SUBMITTAL SUMMARY REPORT PrelimPlat-000713-2026

PLAN NAME: Oak Shores Estates
APPLICATION DATE: 04/30/2026
DESCRIPTION: Oak Shores Estates

Oak Shores Estates
#PrelimPlat-000713-2026

Development Review Committee Waiver Request Form

SHT. 04.04

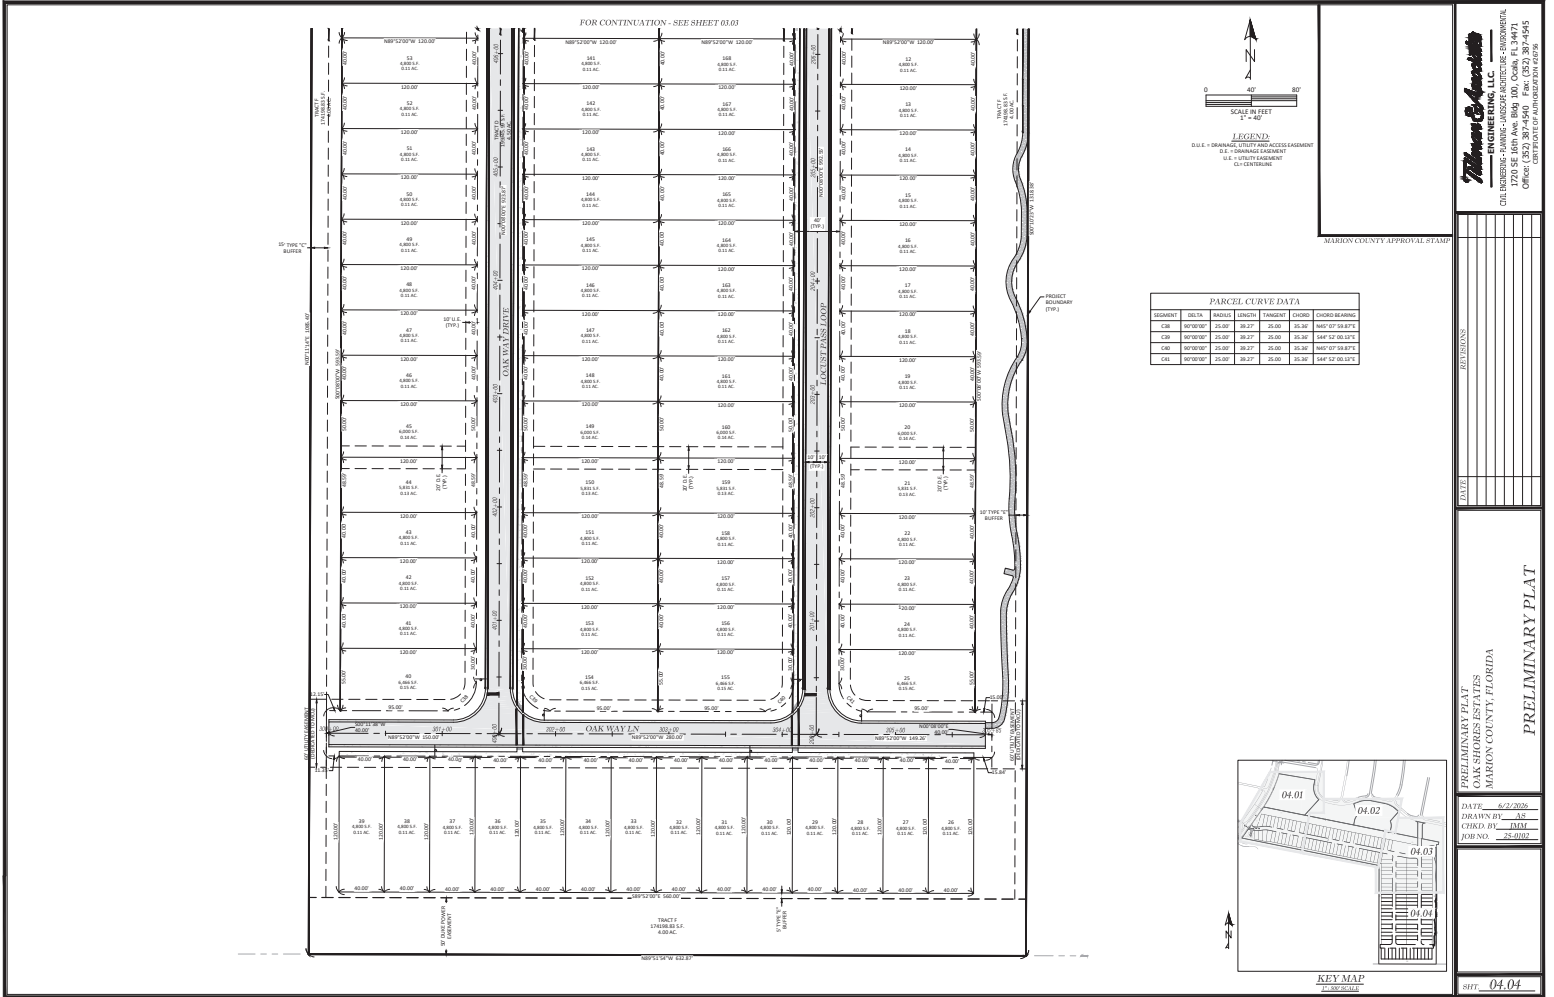
ITEM REVIEW NAME (DEPARTMENT)	ASSIGNED TO	DUE	COMPLETE	STATUS
911 Management (DR) (911 Management)		06/10/2026		Pending Assignment
<i>Corrections</i>	2.12.28 - Road identification (Not Resolved) - Corrective Action: Added new road names to Sheet 03.01. The road names also need to be added to Sheets 04.01 thru 04.04. - 2.12.28 - Road identification: All roads shall be identified by quadrant number as assigned by Marion County 911 Management.			
<i>Corrections</i>	Additional 911 Comments (Not Resolved) - Corrective Action: Sheet 01.01 needs Section 24 removed, and change Range from 24 to 23 (it should be Section 23, Township 16, Range 23). - Additional Comments:			
Environmental Health (Plans) (Environmental Health)		06/10/2026		Pending Assignment
Fire Marshal (Plans) (Fire)		06/10/2026		Pending Assignment
Growth Services Planning & Zoning (DR) (GS Planning and Zoning)	Erik Kramer	06/10/2026		Pending Assignment
